Design Change Notification

To: Sanyo Denki America Cooling DistributorsProduct: Centrifugal FanModel: 9TGA48P0G001, 9TGA24P0H001SANYO DENKI CO., LTD.
Design Dept., Cooling Systems Div.

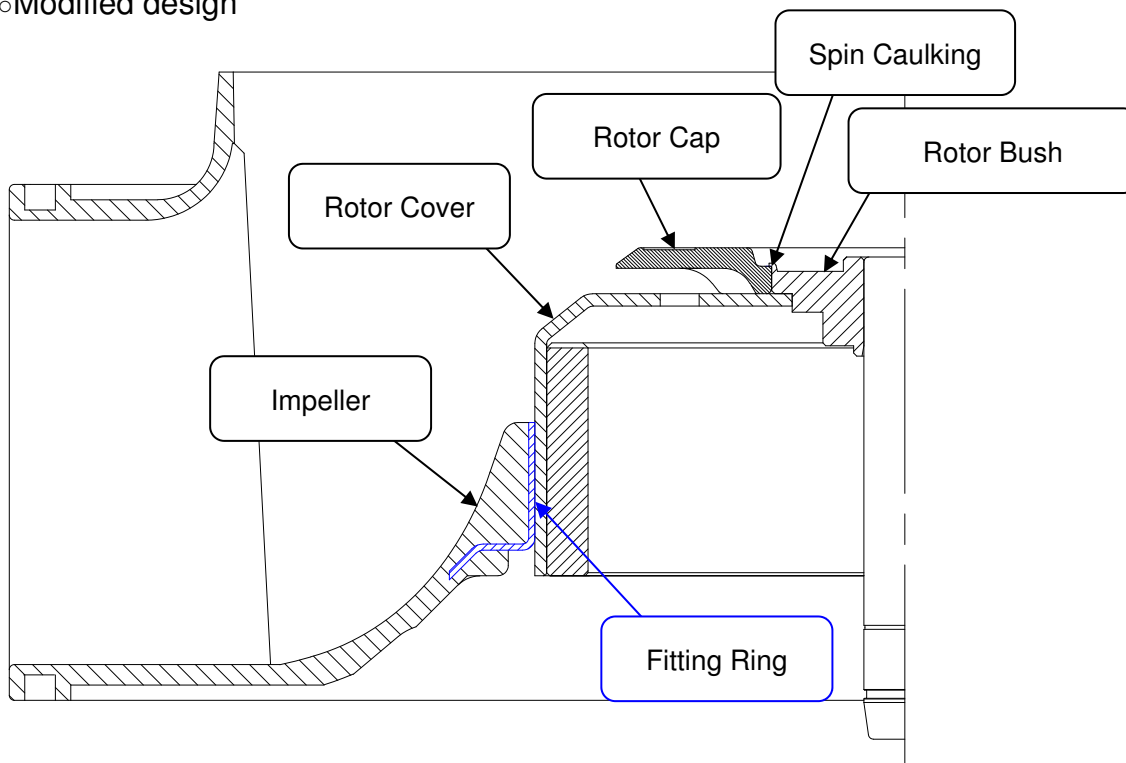
| No | Contents | Existence | Modification | Description |
|----|-------------------------------|---------------------------------|---------------------------------|--|
| 1 | Design changing of the rotor. | Please refer A0041785 Appendix. | Please refer A0041785 Appendix. | <p>We would like to change the rotor design to improve the commonality of parts with other models.</p> <p>There is no influence on its performance and quality by the change.</p> <p>Implementation Date: From the production in October or November 2018.</p> <p>Please note that the schedule might be changed due to initial material availability.</p> |

- Changing the adhesion between impeller and rotor cover from adhesion, to press fitting by a fitting ring.
- Changing the adhesion between rotor cap and rotor cover thermal caulking by the rotor cap, to spin caulking by a rotor bush.
- The design between existing impeller and modified impeller are same without fixing part of impeller and rotor cover.
